Sundry Print Report
05/15/2024

Well Name: KING Well Location: T30N / R10W / SEC 22 / County or Parish/State: SAN

Sundry ID: 2789933

Type of Action: Recompletion

King #1A

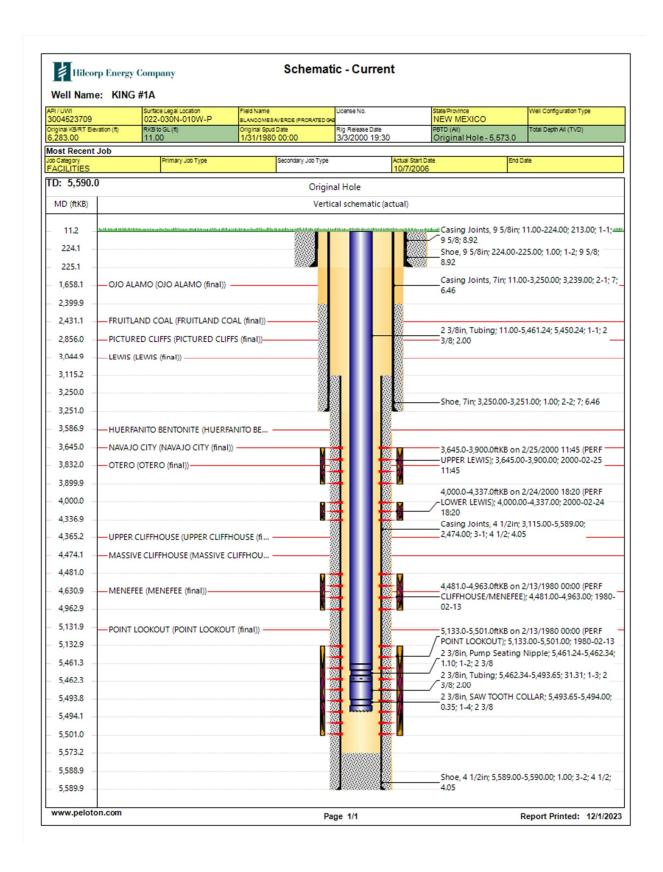
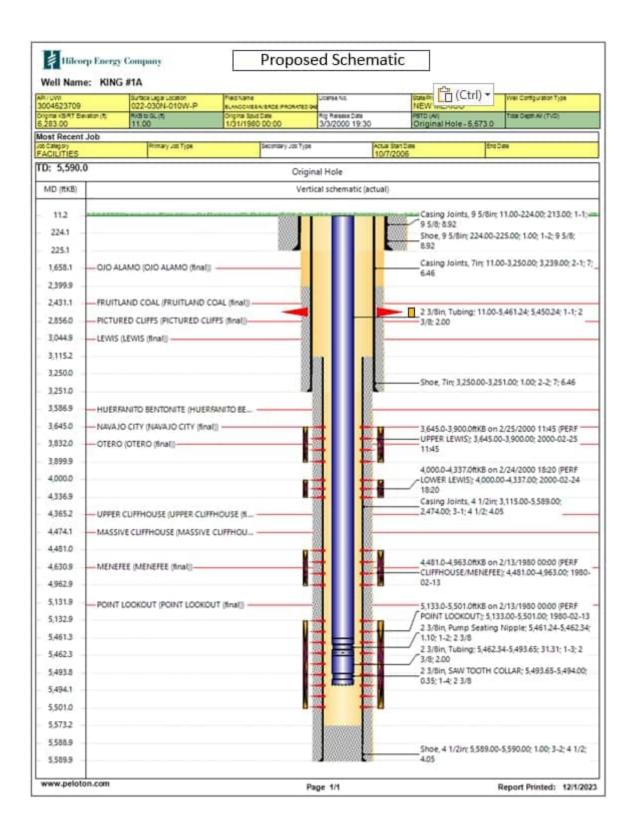
Procedure Description: Revised NOI: Hilcorp Energy Company requests permission to recomplete the subject well in the Fruitland Coal formation and downhole commingle with the existing Mesaverde formation. Please see the attached procedure, current and proposed wellbore diagram, plat and natural gas management plan. A closed loop system will be used. A pre-reclamation site visit was held on 10/17/2023 with Roger Herrera/BLM. The reclamation plan is attached. **Revised perf range.

- MIRU PU and associated equipment. Kill well and NDWH.
- 2. NUBOP and unseat tubing, tag for fill and lay down 2 3/8" string
- 3. Set 7" CIBP at +/-2856' to isolate existing MV completion

- 4. RU wellcheck and MIT wellbore to 500 PSI
- 5. Run CBL from CIBP to surface.
- 6. PU 7" frac packer and frac string, RIH and set packer at 2400'
- 7. Pressure test frac string to 5000 PSI

- 8. MIRU frac spread.
- 9. Perforate and frac the Fruitland Coal from 2612' to 2880'.
- 10. MI flow back and flow well to relieve pressure if needed.
- 11. MIRU service rig.
